# **Civic Hospital Neighbourhood Association**

*Comments and Recommendations regarding  
D07-12-21-0059 and D07-21-2007  
The Ottawa Hospital Site Plan Control (Master)  
and Lifting of Holding Zone*

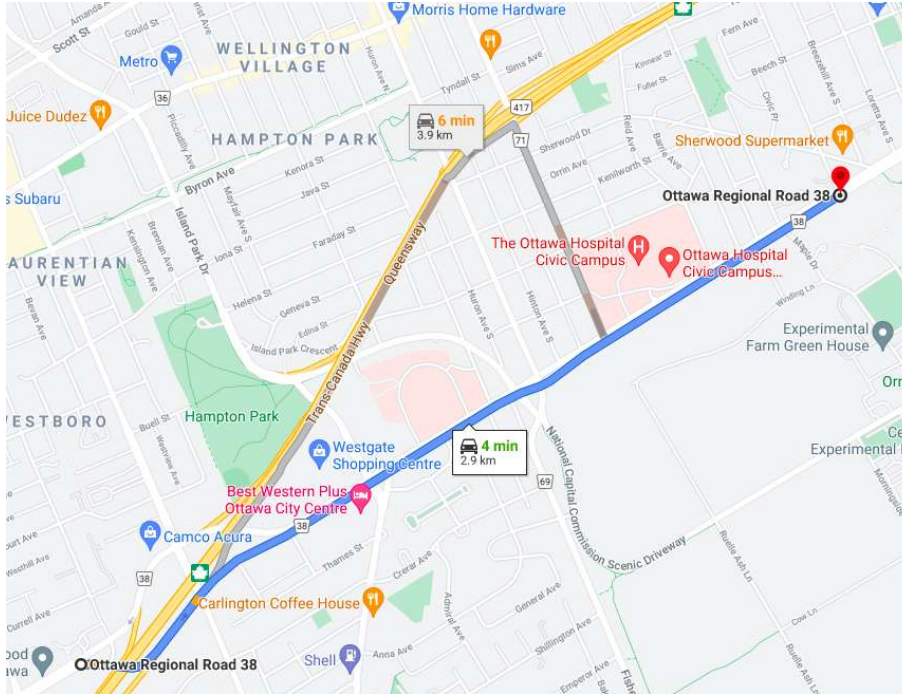
A compromise alternative would be to redesign Parkdale as a one-way road northbound from Carling to the 417 interchange. This has merit for two reasons:

i) vehicles arriving from the west would access the new campus from the 417 EB-Carling exit or the 417 EB-Rochester exit; vehicles arriving from the east would use the 417 WB-Bronson exit, which would be consistent with H signs position; and

ii) this design would likely have more support from the community because people generally access the 417 from the neighbourhood. Residents may rather compromise on taking another road when exiting 417 to get home (southbound) rather than when they are going places from home (north bound).

***CHNA position: Make Parkdale a one-way northbound road from Carling to the 417 interchange.***
